Trees on the Arborist's report for 771 and 773 First Street.

RE: Design Review, Tree Removal, Tree Protection Plan for 771 and 773 First Street  
File 2021-28

Re: Design Review, Tree Removal, Tree Protection Plan for 771 and 773 First St.  
file 2021-2028

Square footage of neighboring properties are indicated in blue.  
Source is public records compiled at datatree.com.

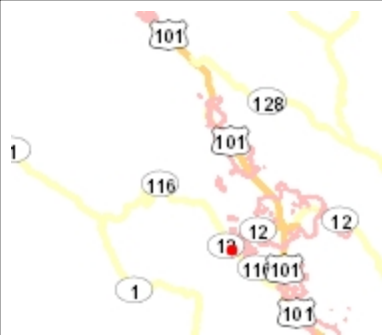
While we do not have numbers, general observations of the neighborhood indicate that most if not all homes on First Street and the Swain Woods neighborhood are in the 1,500 to 3,000 square foot range (our house to the northeast is approximately 2,650 sq. ft.). There are no residences in the First Street or Swain Woods neighborhoods anywhere near as massive as the proposed project.
